CITY OF DOVER

PLANNING TECHNICAL REVIEW COMMITTEE –AGENDA

CIVIL CONSULTANTS MEMORANDUM

TO:	City of Dover Planning Department	FROM:	Geoffrey R. Aleva, P.E.	DATE:	09/15/2021
SUBJECT:	Technical Review Committee Minutes / Response Memorandum				
PROJECT:	725 Central Avenue (2117800)

PROPOSED SITE PLAN PLAN

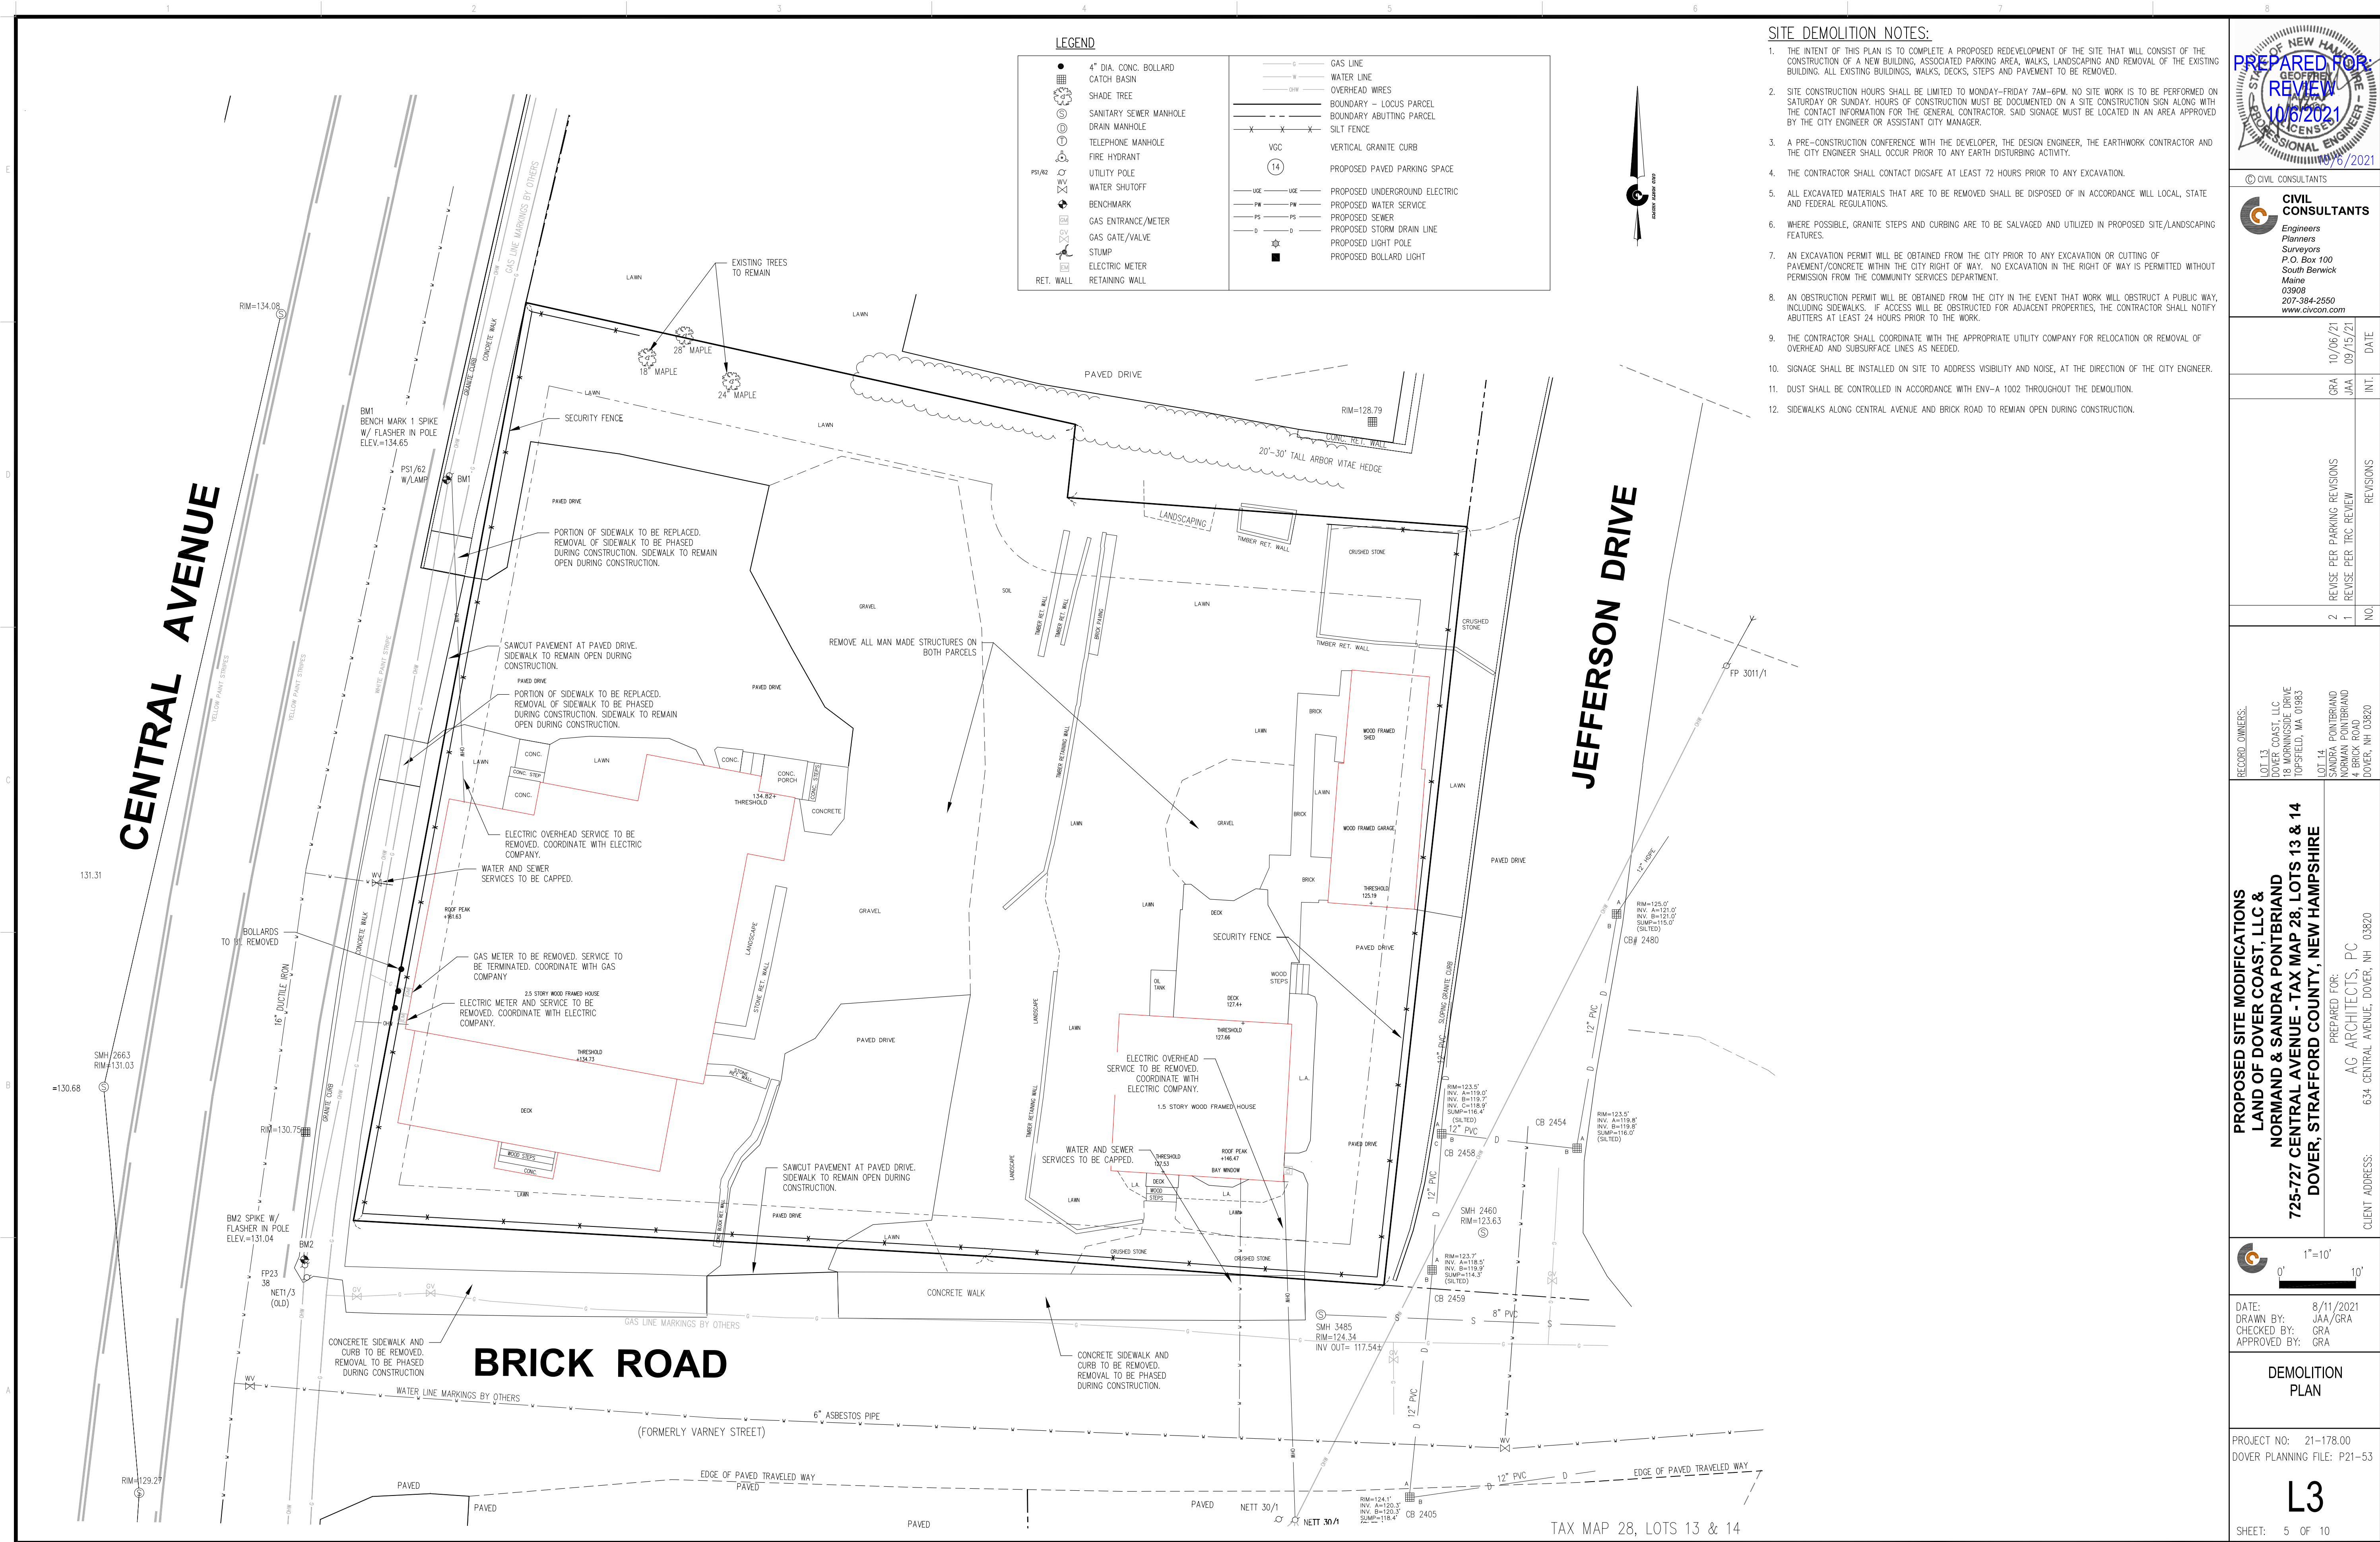
COMMENT	RESPONSE
<u>Engineering Comments:</u>	
Eliminate the parking on Brick St	Parking has been removed.
I have not reviewed the drainage yet. Pending.	Drainage Details will be provided, Consultant will be working with City Engineer.
The city will be installing a new water main on Central Ave in the near future. Can you come off that side of the building?	Water line has been relocated to Central Ave
Cut and cap existing water service	Notes have been added to the plans
Add street trees along Central Ave	Please refer to the attached Landscaping plans
<u>Police Department Comments:</u>	
Proposed Brick Road parking is too close to Central Avenue, and middle 18' parallel space is not viable. Reduce from 3 to 2 spaces and increase the distance from Central Ave.	Parking has been removed.
Proposed design - even with additional parallel parking added on Brick Road – still falls short of parking requirements. Consider eliminating the ground floor unit (reduce from 13 to 12) then reconfigure basement and unit storage area to accommodate a second row of interior parking. This would also allow you to eliminate the additional Brick Road parking.	We are seeking a waiver for the maximum parking counts. The design has 21 onsite parking stalls. The Applicant is pursuing several potential options to provide additional offsite parking. If that parking can be secured, the waiver request would be withdrawn.

COMMENT	RESPONSE
The access aisle for the accessible parking space shall be a minimum of 8' wide if an 8' parking space is provided. Expand striping width	Site Plans have been revised.
Does the garage have access control- indicate means for first responder access/access control bypass.	The garage will not have a door to enclose the garage area.
Wall requires Building Permit	To be applied for after site plan review
<u>Economic Development:</u>	
Appreciate the material samples	Provided in this submission
Which polymer is the shingles? Would like to know weathering/durability	The Architect has provided information in this submission regarding this request. See Attachment 3
<u>Planning Board Comments:</u>	
Add screening of transformer, etc.	See Landscaping Plan for details
